RELEVANT CONSIDERATIONS REGARDING PROPOSAL TO ERECT A SINGLE STOREY DWELLING AT 67 SOUTHWOOD RD H.I.

HBC Ref APP/16/00714

Sheet 2

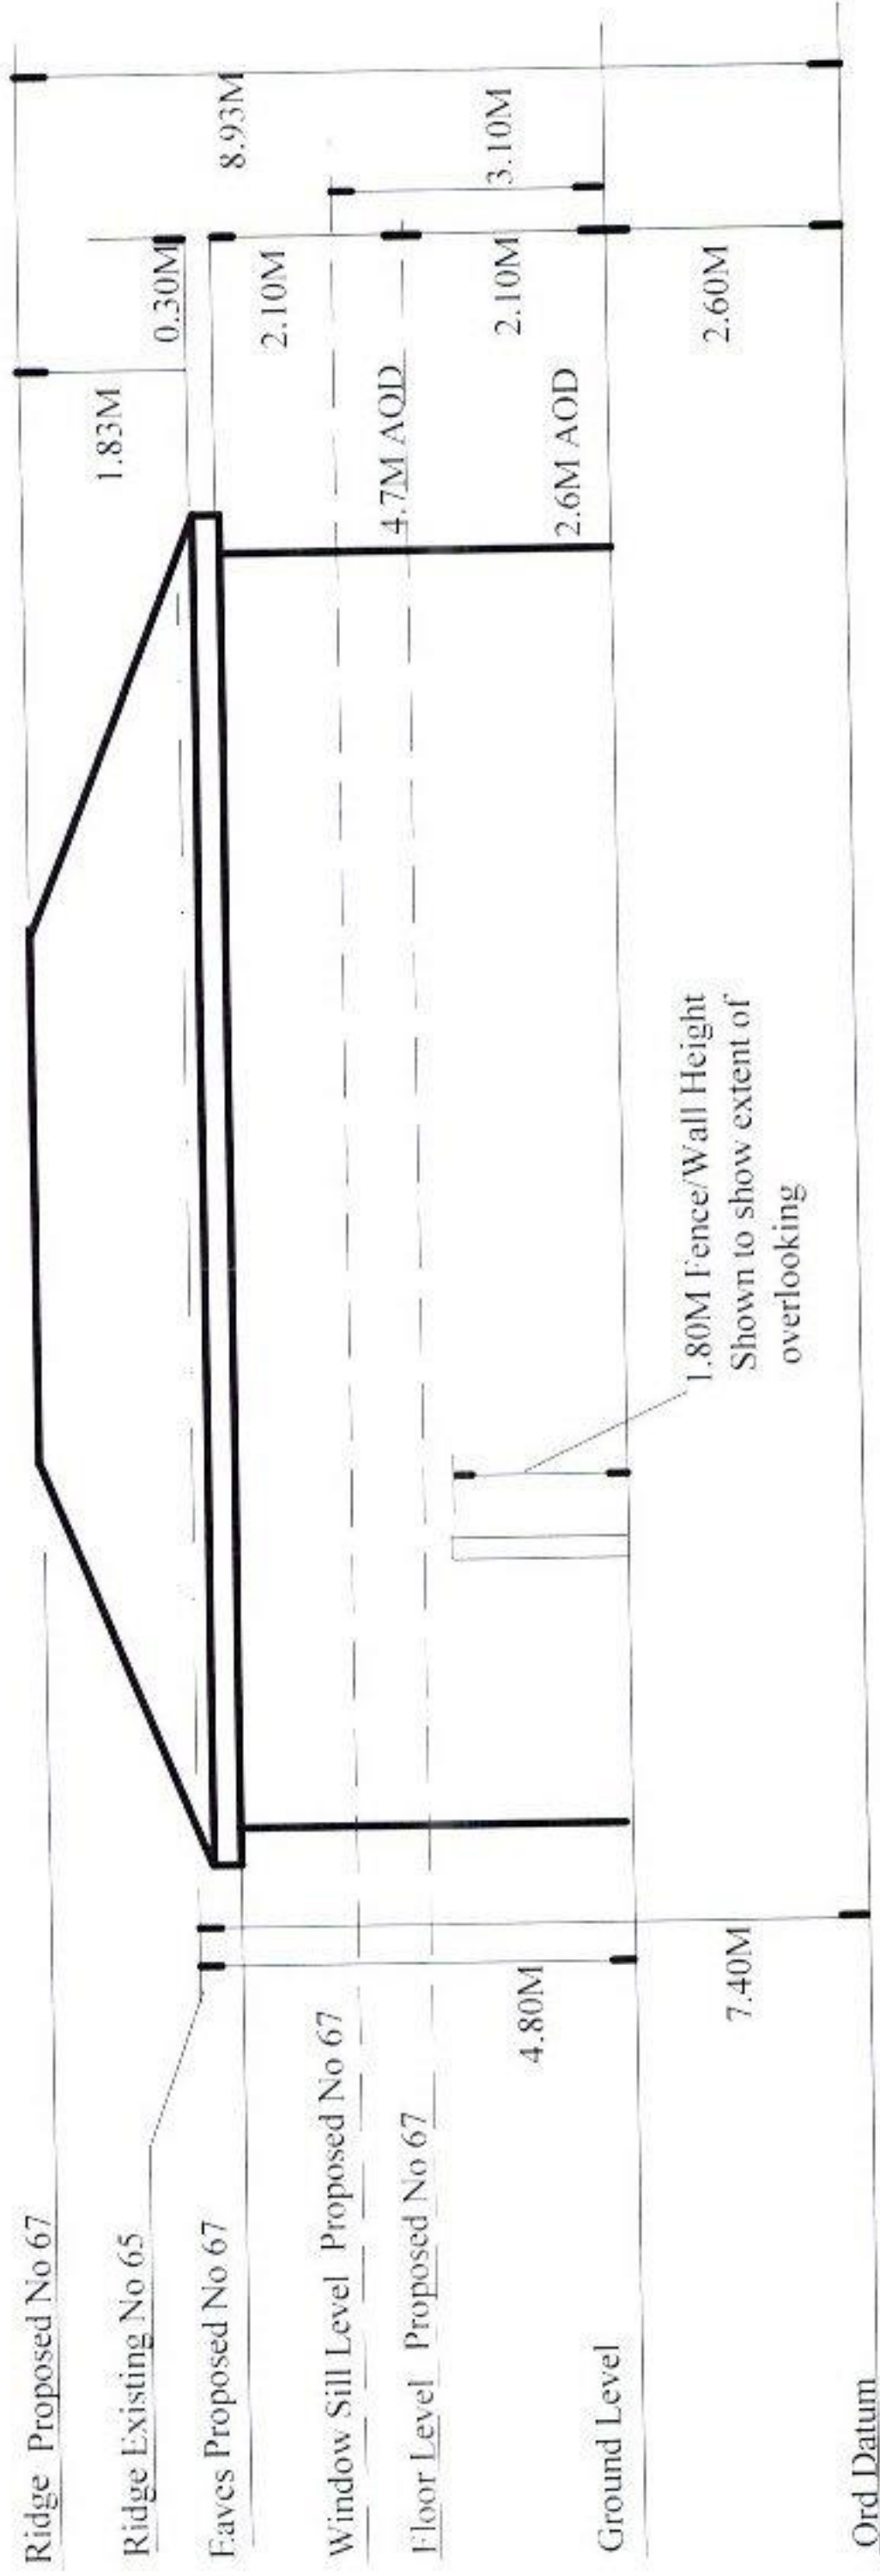
This view shows a profile for the North and South elevations of the proposed No 67

The problem with overlooking and consequent loss of privacy is clearly shown
